Signed [signature] Date 3/15/99
Bureau of Fire Prevention
Marietta Fire Department

future home of
A. G. Edwards & Sons Inc.
Kennesaw House - Marietta Georgia
Developer: Deventer Group
Designer: Richard E. Burgess
January 1999

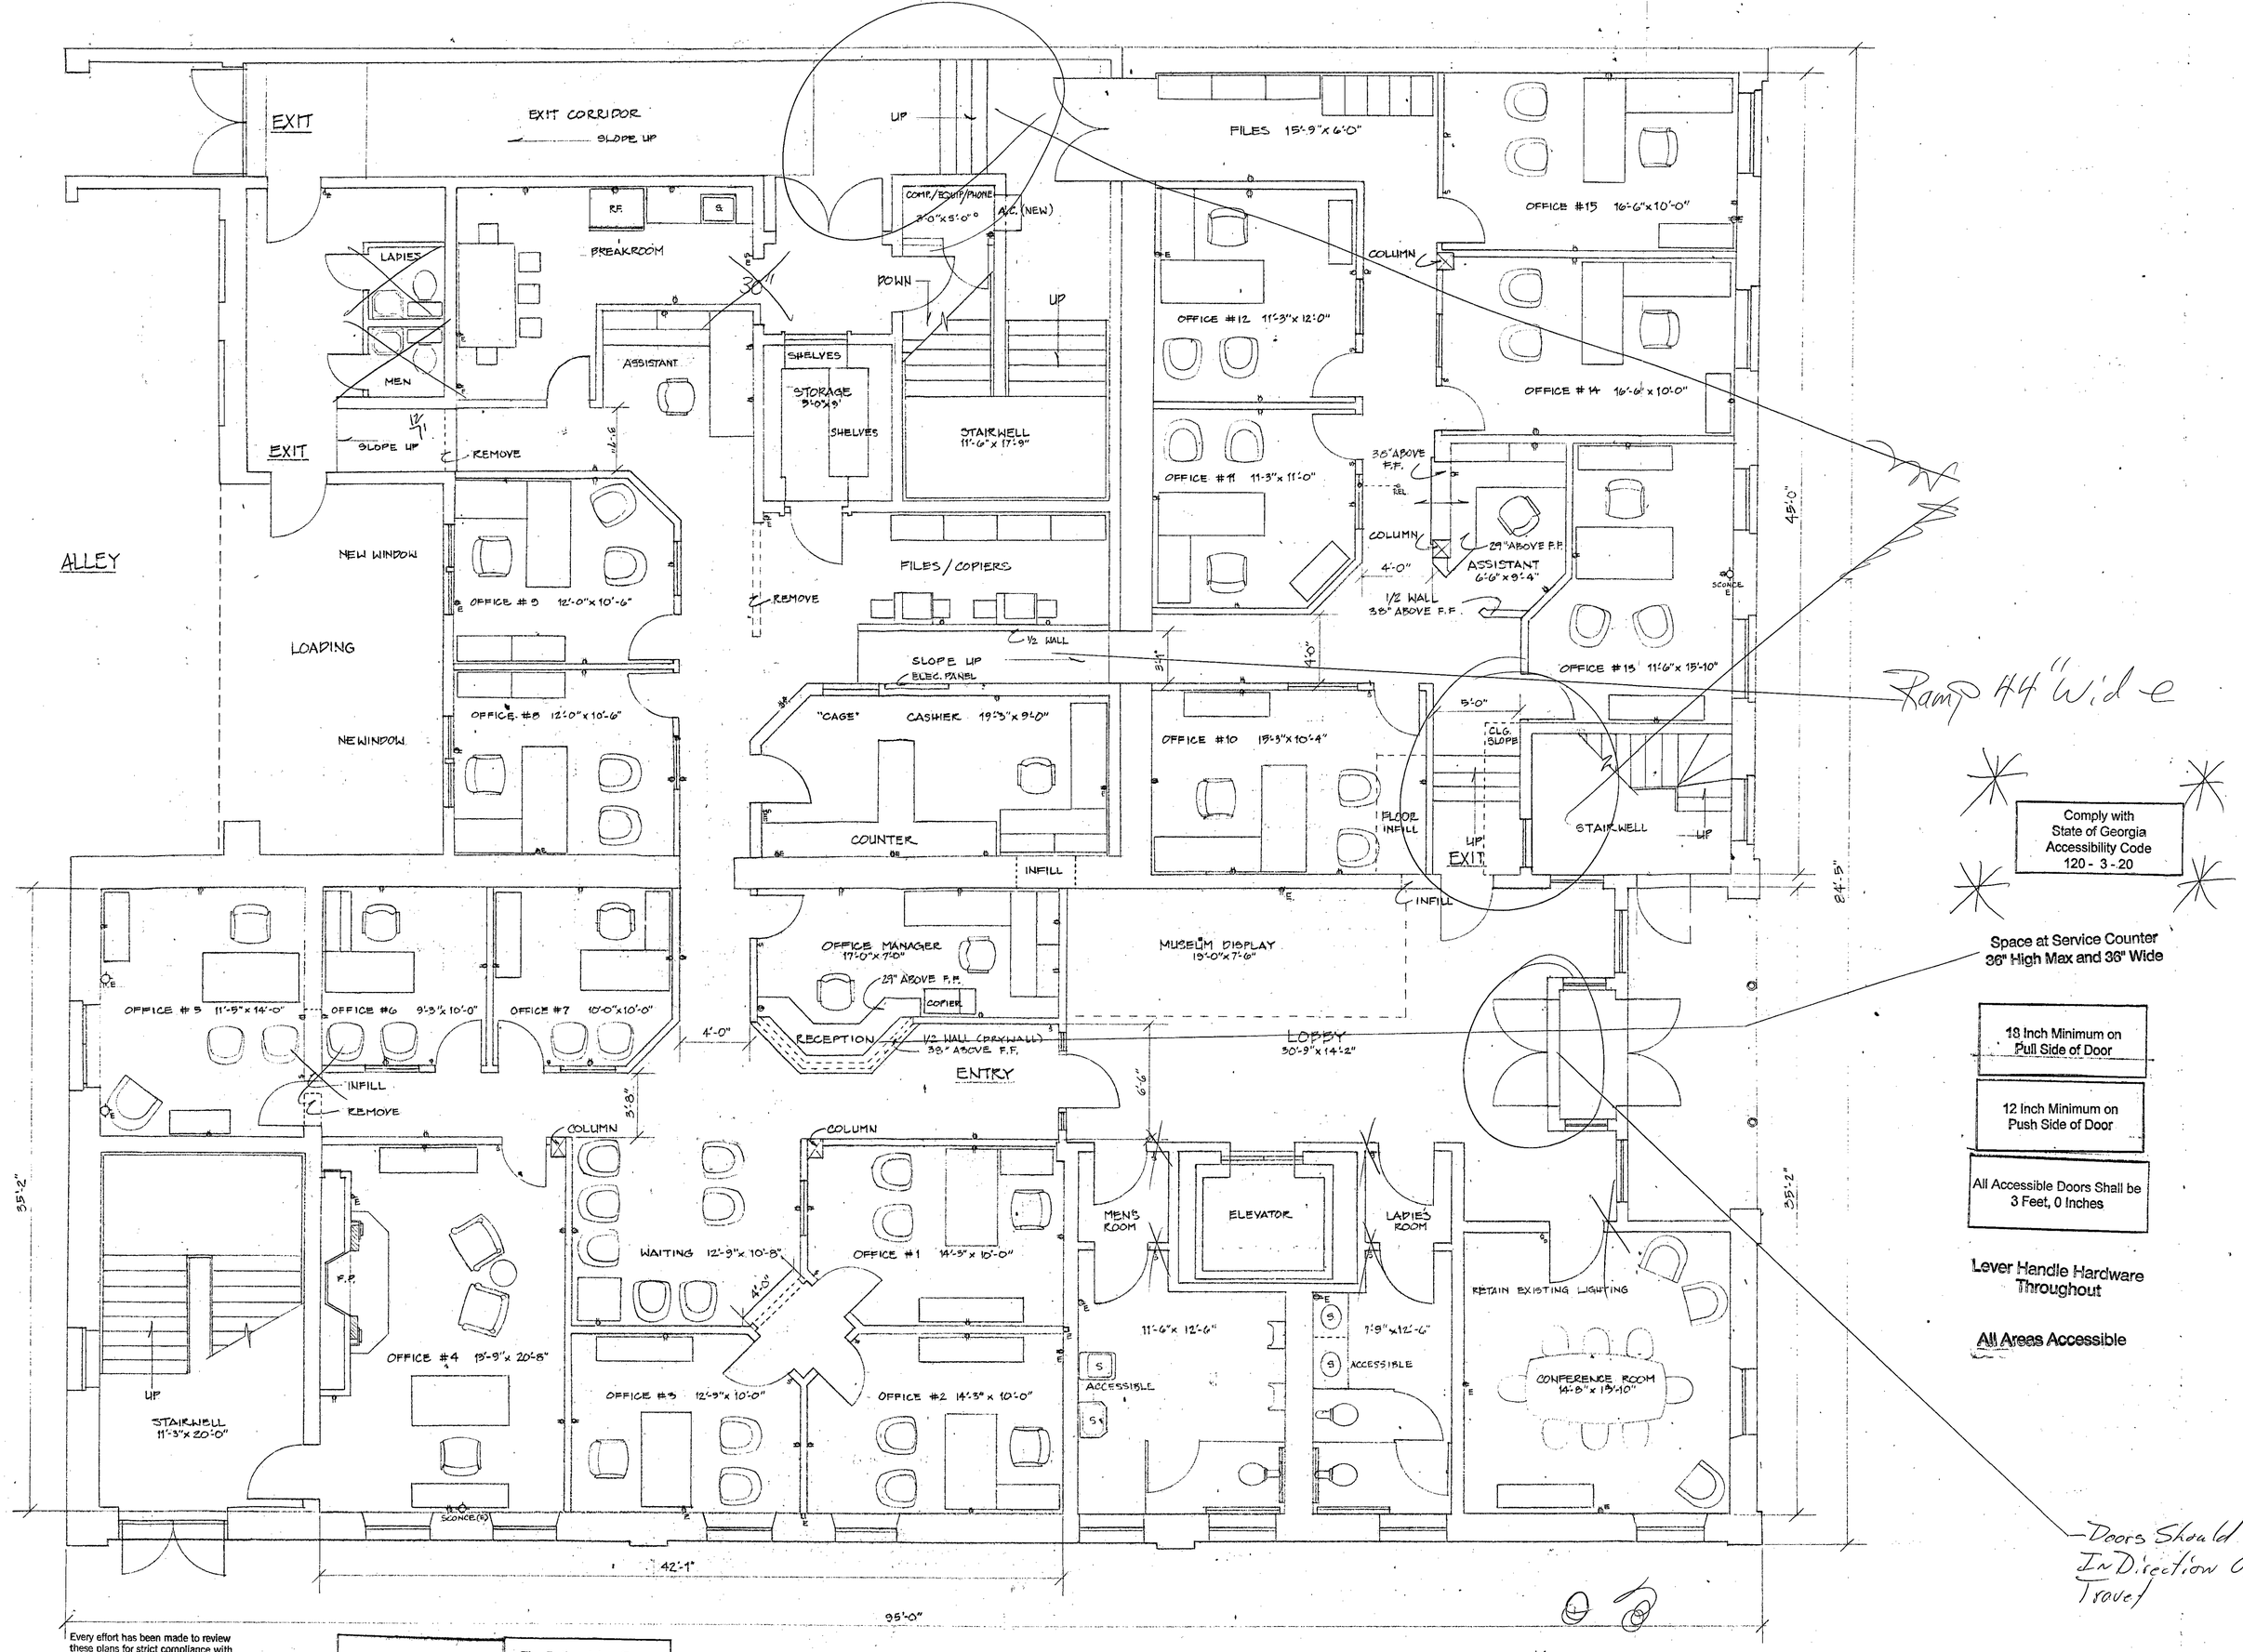
To Comply with: N.F.P.A. 101
Life Safety Code 1997 Edition,
Chapter 26

Emergency Lighting with Battery Backup	Fire Extinguisher Every 75 Feet of Travel, Tagged and Mounted
Exit Signs with Battery Backup	Call for an 80% and a 100% Inspection
